Service Bulletin

Subject: Float Switch Clip, Float Inspections & Troubleshooting

Models: FQG60T, FQG80T, FQG100T & FQG120T Touch Screen Fryers

7/2/2025

Figure 1 Heavy Duty Grip Ring on Top & Bottom.

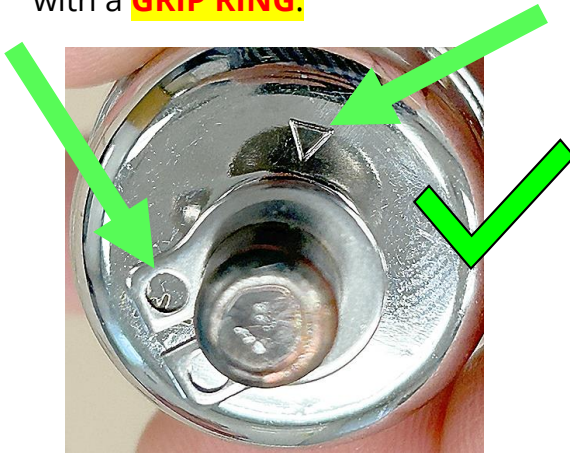
1. If the float switch has a **HEAVY-DUTY GRIP RING** supplied by the manufacturer on **TOP OF THE FLOAT** **AND** a **HEAVY-DUTY GRIP RING BELOW THE FLOAT** (see Figure 1), the float is good stock and **DOES NOT NEED TO BE REPLACED**.
2. If the float switch has an **INDENTED TRIANGLE ON THE TOP OF THE FLOAT** (see Figure 2), it **MUST** have a **GRIP RING ONLY** on the **TOP OF THE FLOAT**. If it has an **E-clip** on **TOP OF THE FLOAT** (see Figure 3), the **E-clip** **MUST BE REPLACED** with a **GRIP RING**.

Figure 4 Float switch with **NO** triangle on top.

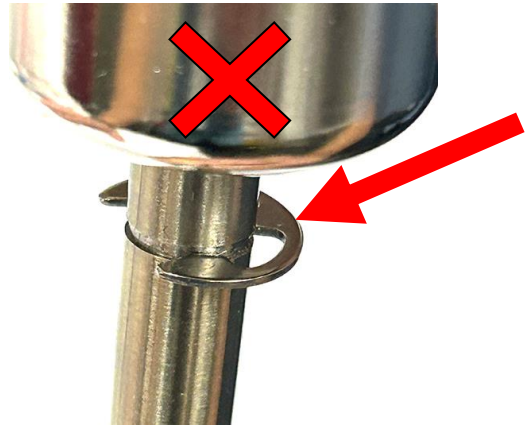
3. If the float **DOES NOT HAVE A TRIANGLE** on the **TOP OF THE FLOAT** (see Figure 4) **AND** it has an **E-clip BENEATH THE FLOAT** (see Figure 5), **IT MUST BE REPLACED** with kit PN 8262541!

Figure 6

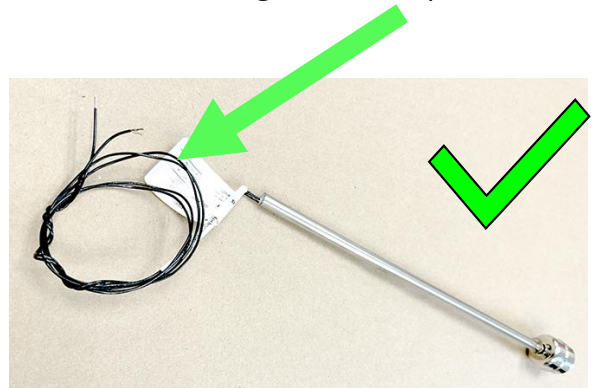
When replacing float switches with kit PN 8262541, ensure that only float switches **WITH BLACK LEADS ONLY** (see Figure 6) are used as replacements.

Figure 7

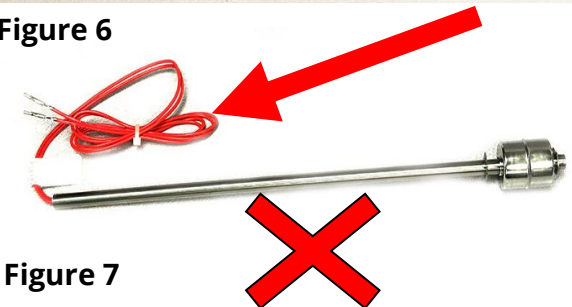
FAS's should order replacement kits first. Once they receive the new kits, they should return any 8262541 kits with **RED** leads (see Figure 7).

Figure 8

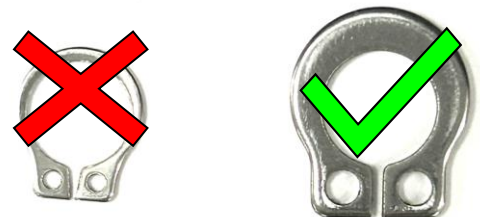
Standard snap rings **SHOULD NOT** be used (see snap ring on the left in Figure 8). They will not hold and will come loose.

ONLY HEAVY-DUTY GRIP RINGS from the manufacturer (see grip-ring on right in Figure 8) should be used.

Figure 8

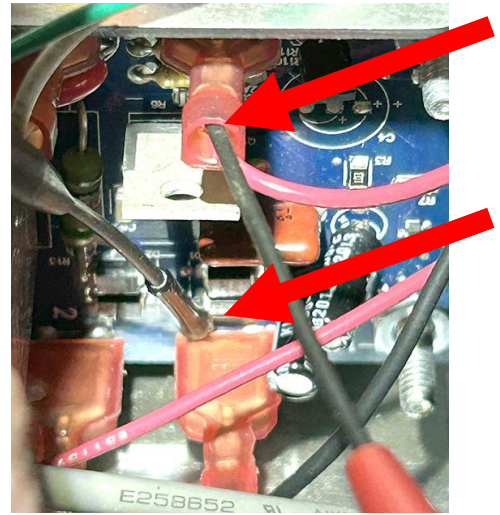
- i. Test across pins 1 (Red) & 8 (Black) (see Figures 8, 10 & 11). 24VDC should be present with the switch activated.
- ii. Test **across pins** 6 (green) & 7 (white) or 2 & 3, depending which pins have green and white attached (see Figures 9, 10 & 11). The voltage should be near 0VDC when activated. If the voltage is above 0.3VDC with power on and contacts closed, the time delay relay must be replaced.
